A d d e n d u m

Iowa Department of Transportation
Office of Contracts

B.O.	Proposal ID	Proposal Work Type	County	Project Number	Addendum
158	31-0522-131	HMA RESURFACING	Dubuque	STPN-052-2(131)--2J-31 NHSN-061-8(137)--2R-31 NHSN-151-5(167)--2R-31	21APR158.A01

Replace SHEETS B.2, C.6 with the attached SHEETS B.2, C.6 NHSN-151-5(67)--2R-31

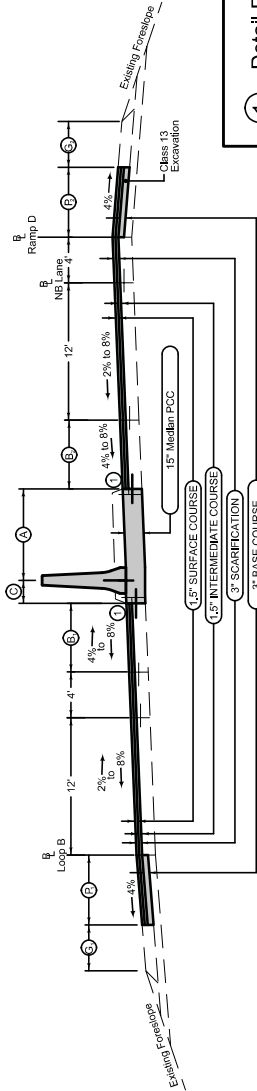
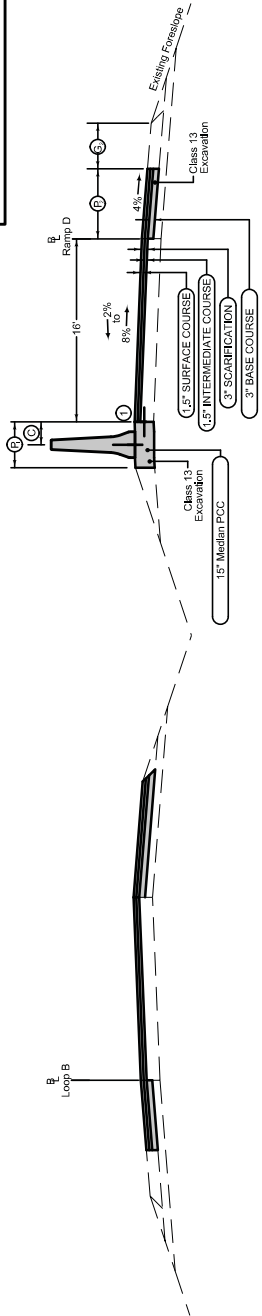
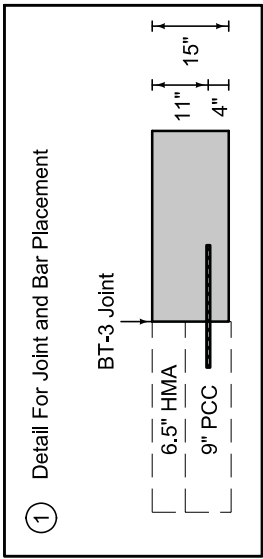
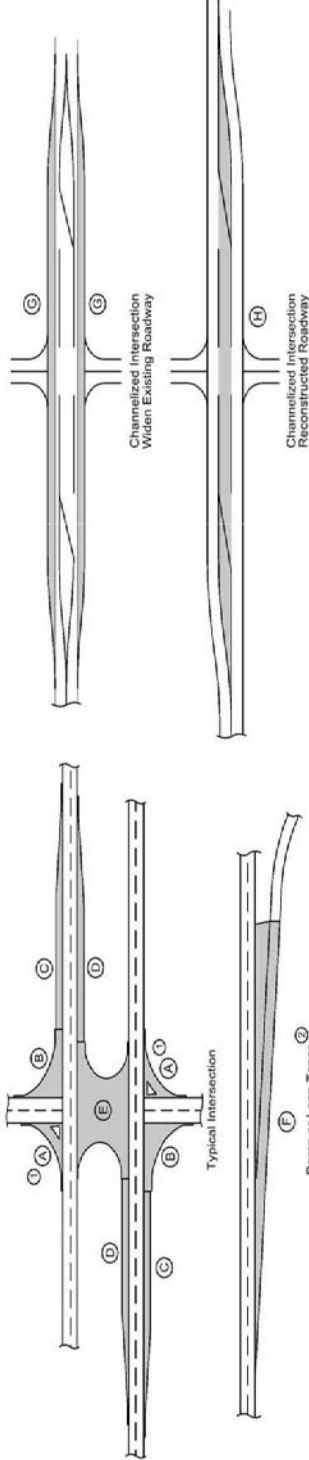
2301-4874500: Refer to Tab. 100-24 in the C sheets for location and details:

(1) To be constructed in median where concrete barrier rail is located.
